UNITED STATES PATENT AND TRADEMARK OFFICE
CERTIFICATE OF CORRECTION

PATENT NO. : 7,151,218 B2
APPLICATION NO. : 10/764105
DATED : December 19, 2006
INVENTOR(S) : Cong Thanh Dinh

(54) **ELECTRICAL TERMINATION COMPONENT
BRACKET**

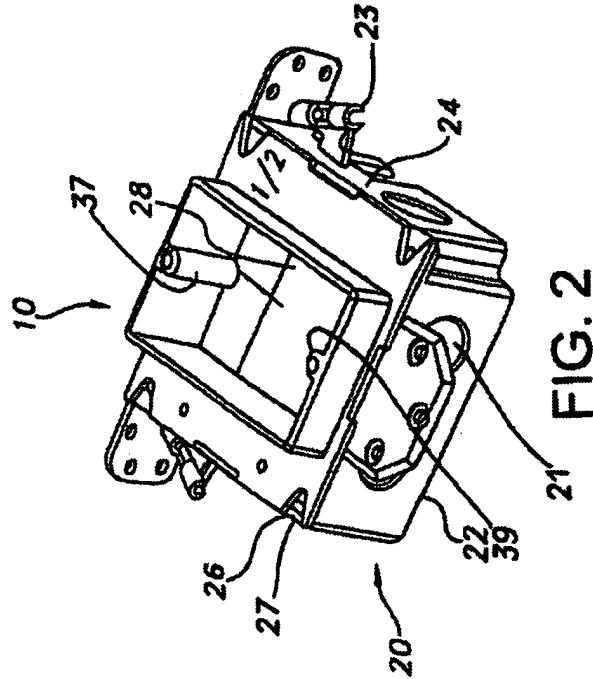
In Figure 1, previously omitted elements 21, 23, 37, and 39 have been added.

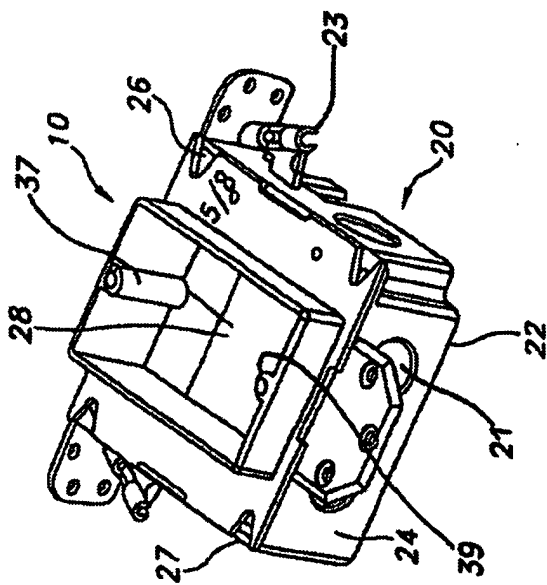
In Figure 2, previously omitted elements 21, 23, 37, and 39 have been added.

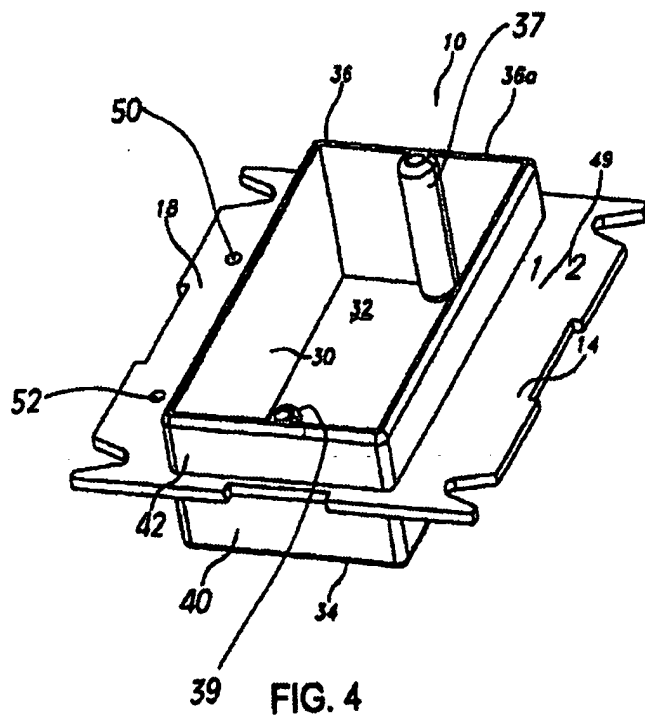
In Figure 4, previously omitted elements 37, 39, 50, and 52 have been added. Also, element "42" was replaced with element --40-- and element "40" was replaced with element --42--.

FIG. 5

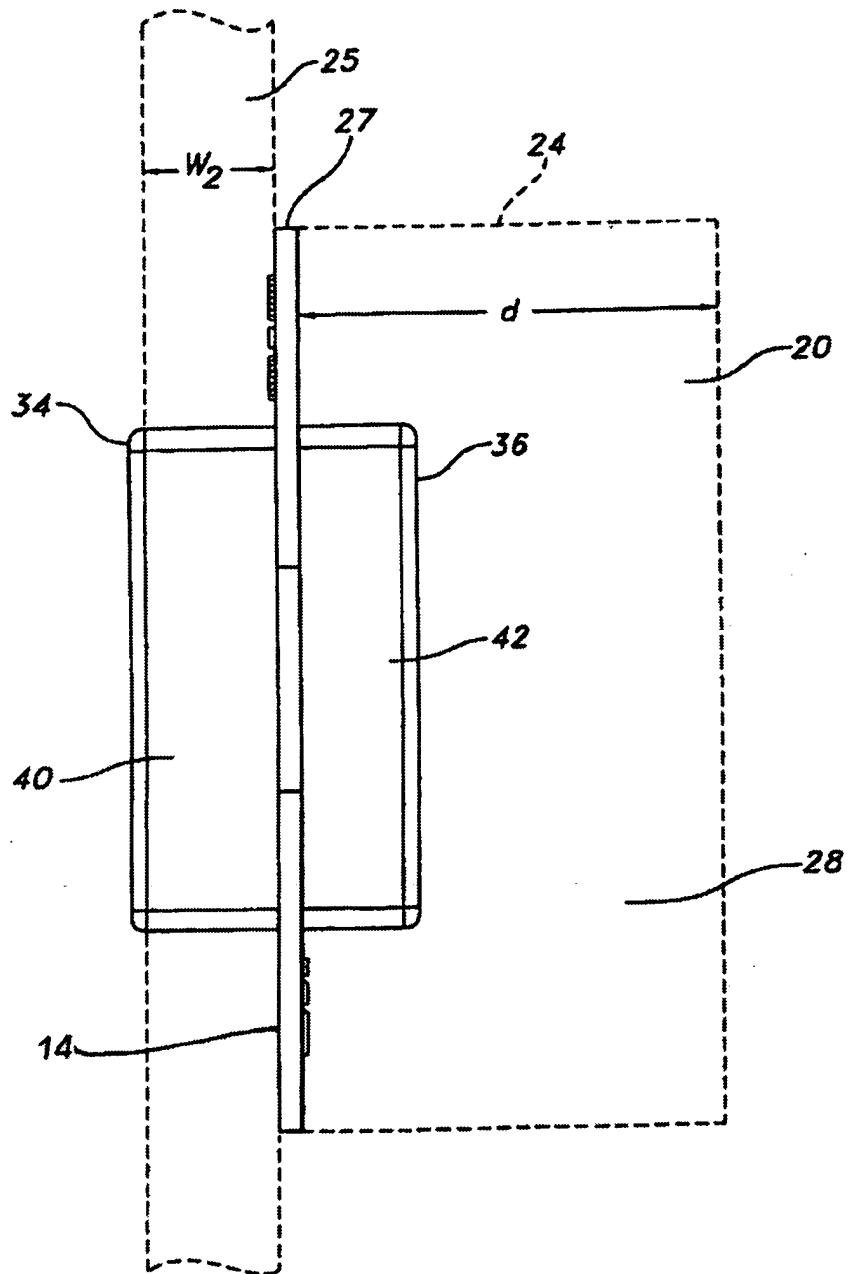
In Figure 5, previously omitted element 14 was added.

FIG. 6

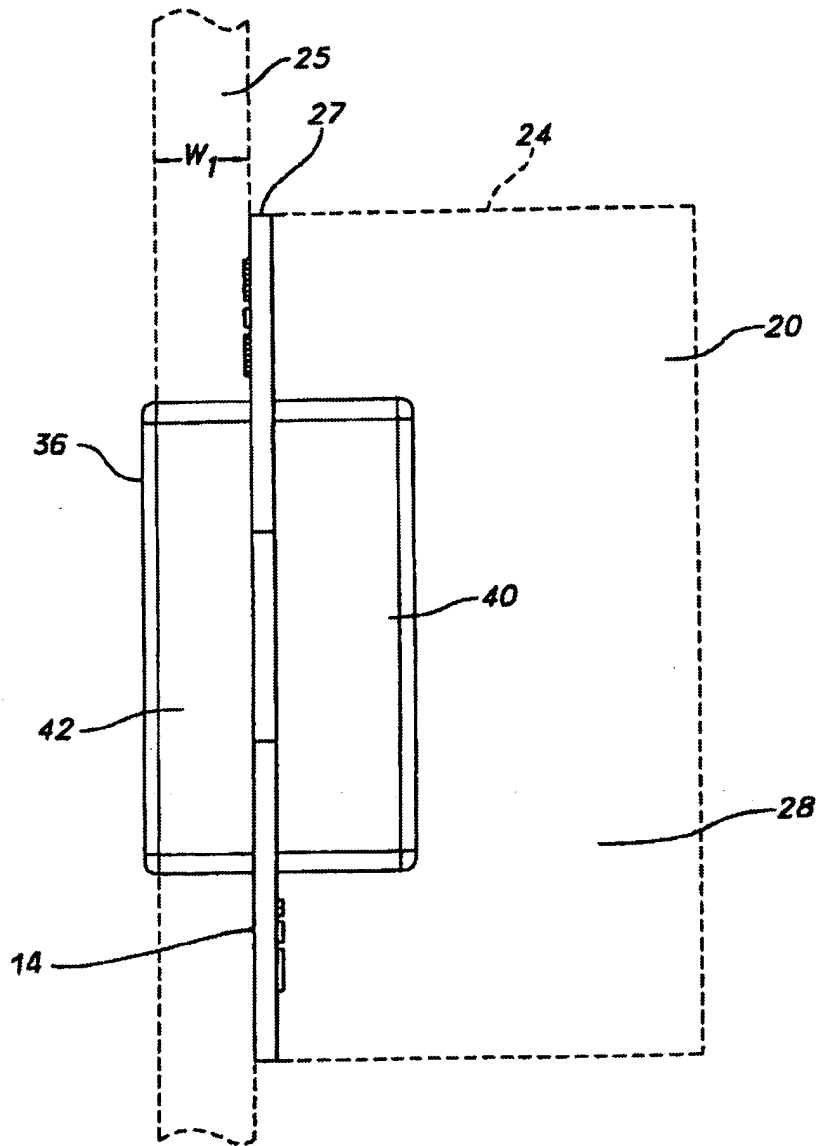
In Figure 6, previously omitted element 14 was added. Also, element "34" was replaced with element --36--.
